Attachment 5 – Schedule of Modifications

Note: the modifications or additional information required as detailed below are to be reflected in the Structure Plan, Structure Plan Report and the relevant Appendices, to ensure consistency.

Attachment 1 – Structure Plan Road Layout Modification

Attachment 1 - Structure Plan Road Layout Modification

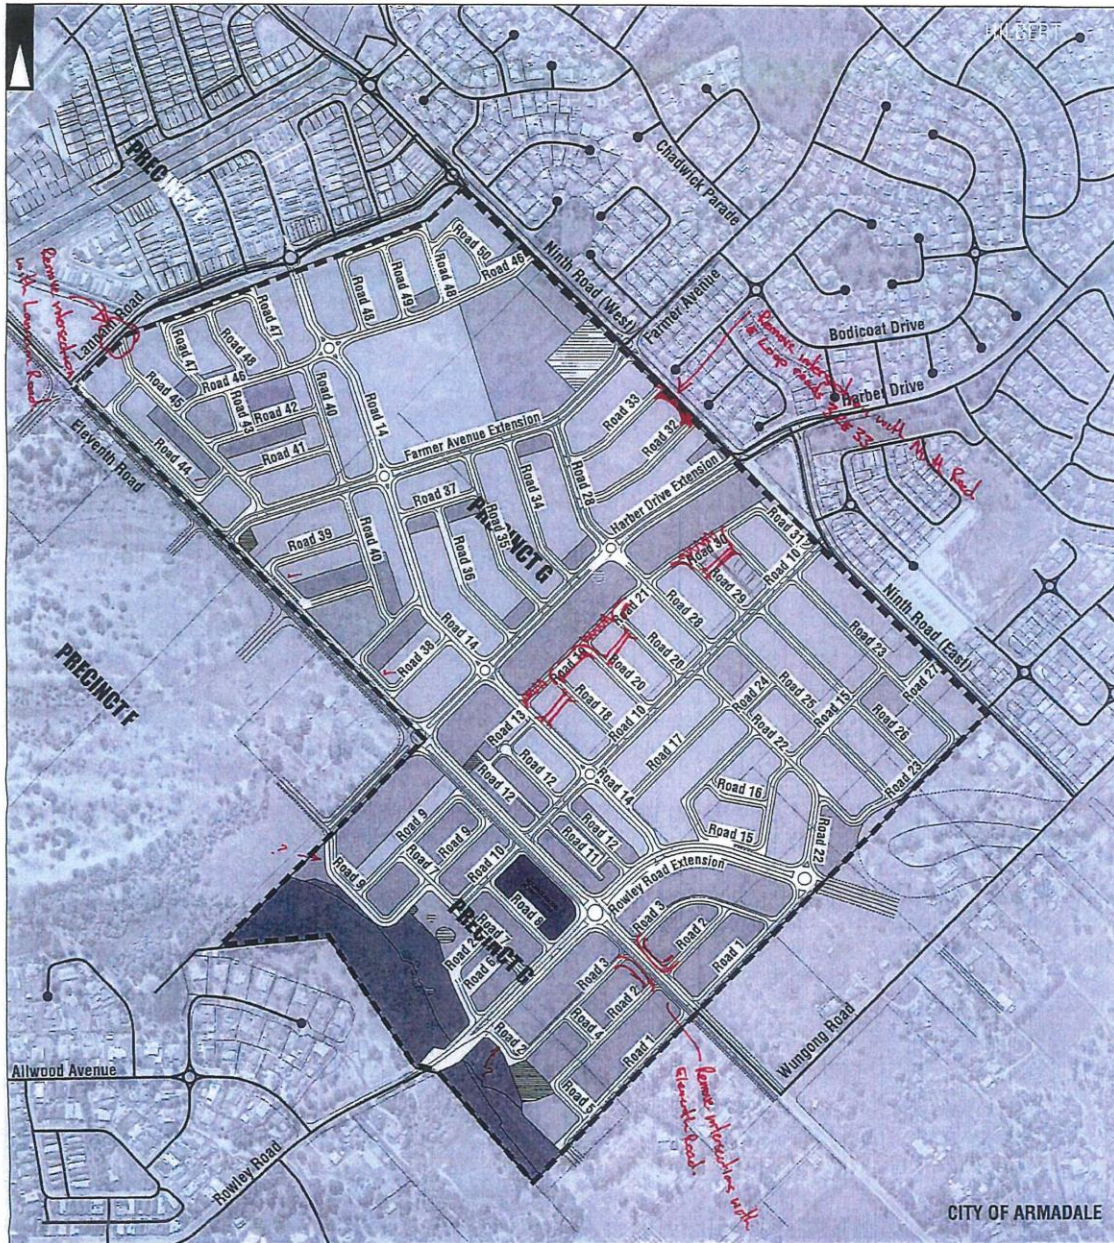
- m. Section 3.11 Movement Networks – the two cul-de-sacs (abutting Ninth Road, between the Evelyn Gribble Community Centre and the proposed Harbor Drive extension) are to be joined into one 'loop' road to improve the legibility of the road network. Amend intersections as per attached sketch (refer to Attachment 1).

- n. Section 3.11 Movement Networks – The alignment of roads 19, 21 & 30 adjacent to the living stream presents as a 'rat run'. Amend intersections as per the attached sketch (refer to Attachment 1).

- o. Amend the roads intersecting with Eleventh Road as per the attached sketch (refer to Attachment 1).
 - p. Section 3.11 Movement Networks – The land required for wider road reserve/s must be indicated in the Structure Plan and Report.

- q. Section 3.11 Movement Networks – The proposed loop road (to the south of Rowley Road) is to remove the depicted truncations, consistent with the other 'loop' roads to the north to avoid any confusion at subdivision stage. Amend intersections as per attached sketch (refer to Attachment 1).
